REFERENCE: SNM-1168 License, Docket 70-1201

ATTACHMENT I

As stated earlier, the system is composed of large tanks and pumps slightly, internally contaminated. The potential from an accident that would release large amounts of contaminants to the environment is remote. BAW FUEL COMPANY, COMMERCIAL NUCLEAR FUEL PLANT USNRC LICENSE SNM-1168, DOCKET 70-1201 PART I - CHAPTER 5.0 - ENVIRONMENTAL PROTECTION

FIGURE 5.1

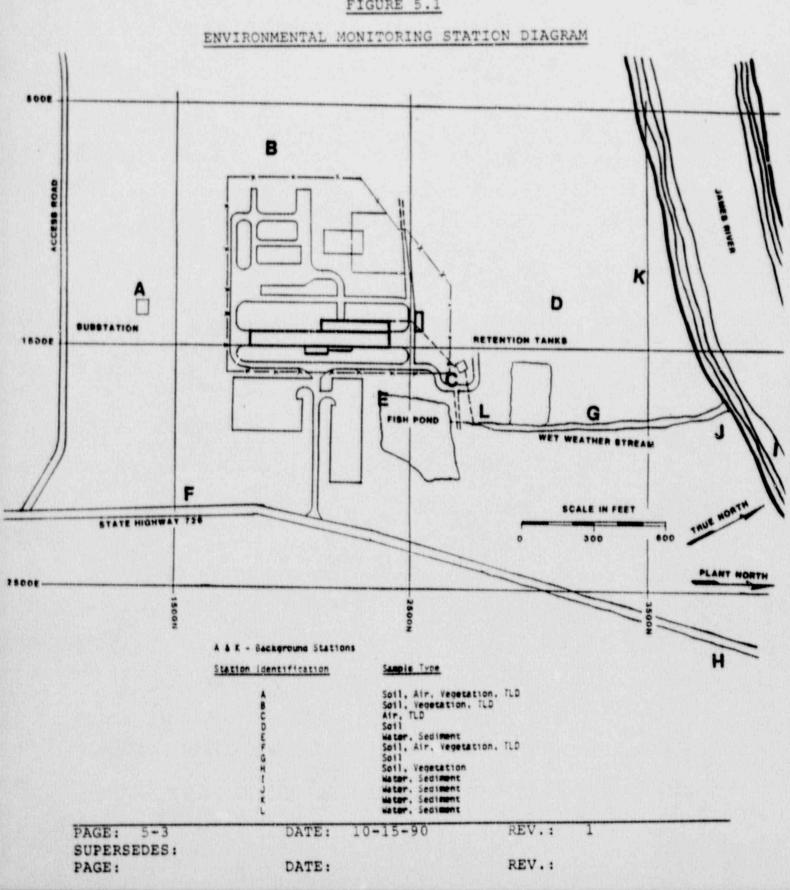
DF LICENSE	SECTION/PAGE	CHANGE
5	Figure 5.1/5-3	SERF-3 was added to the diagram and the new location of the perimeter fence is depicted.
7	Table 7.2/7-8	SERF-3 was added to the decommissioning plan under ancillary area & structures.
7	Appendix A/7-9	The decommissioning cost estimates were increased to include SERF-3. The increase also reflects the most recent estimate based on higher disposal costs; North Carolina rates versus South Carolina.
8		Since the SERF-3 will not decrease the effectiveness of the Radiological Contingency Plan, chapter 8, changes will be submitted upon amendment approval.
9	Figure 9.1/9-7	SERF-3 was added to the diagram and the new location of the perimeter fence is depicted.
10	10.1/10-1	Refurbiahment operations supporting the liquid volume reduction/chemical cleaning process to take place in SERF- 3 were included.
10	Pages 10-2 - 10-4	No changes were made to these pages. However, due to the addition of paragraphs in earlier sections the pages were repaginated.

FIGURE 10.1

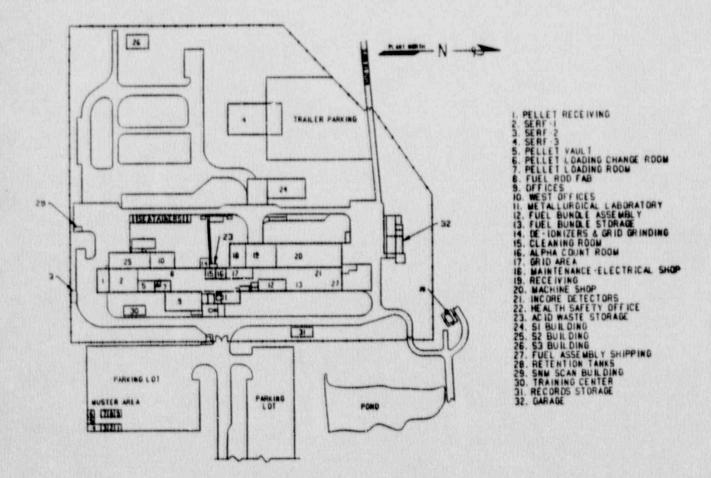
10 Figure 10.1/10-13 SERF-3 was added to the diagram and the new location of the perimeter fence is depicted. 12 12.15.1/12-15 Chemical cleaning and liquid volume reduction equipment was added under Field Operations equipment. 13 SERF-3 was added to the Figure 13.1/13-4 disgram and the new location of the perimeter fence is depicted.
